Access Compliance Report Public Rights-of-Way (Curb Ramps)

Main Street: FLORA_CT Cross Street: GOSSAMER_PL Location: NW

ADA ID: RPAT211101101847 Ramp Type: Type 4 - Parallel Initial Pass/Fail: Pass Overall Compliance: No Severity Score: 16

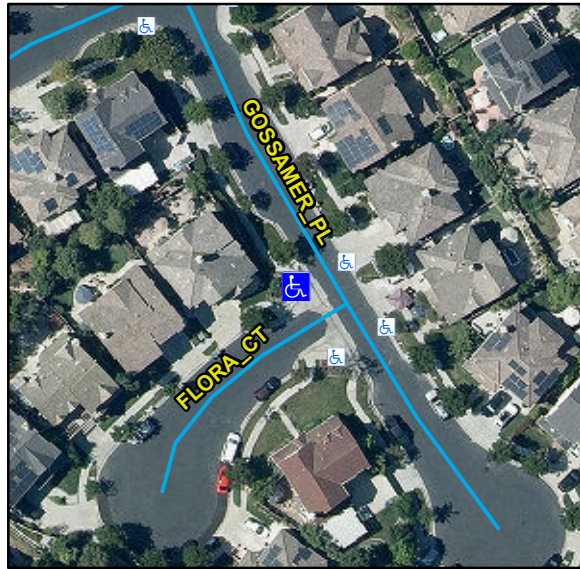
R204.3, R304.2.2-Perp, R304.3.2-Para, R305, R304.5.4, STD 1115

Crossing 1 Slope (%)	1.5		Crossing 2 Slope (%)	0.7
	Crossing 1 Cross Slope (%)	2.3		Crossing 2 Cross Slope (%)	1.3
Yes	Gutter Ponding	No	Yes	Curb Slope	5
Yes	Gutter Lip Height (in)	0		Road Run Slope (%)	3.6
No	Gutter Run Slope (%)	8		Road Cross Slope (%)	2
Yes	Gutter Cross Slope (%)	2.8	No	Perpendicular Joint Present	No
Yes	Overall Surface Condition	Acceptable			
	Cross Gutter Present?	Yes		Spandrel Present?	Yes
	Replace Cross Gutter?	No		Replace Spandrel?	No

Remove & Replace Curb Ramp With Two New Directional Ramps or Equivalent. Remove & Replace Gutter.
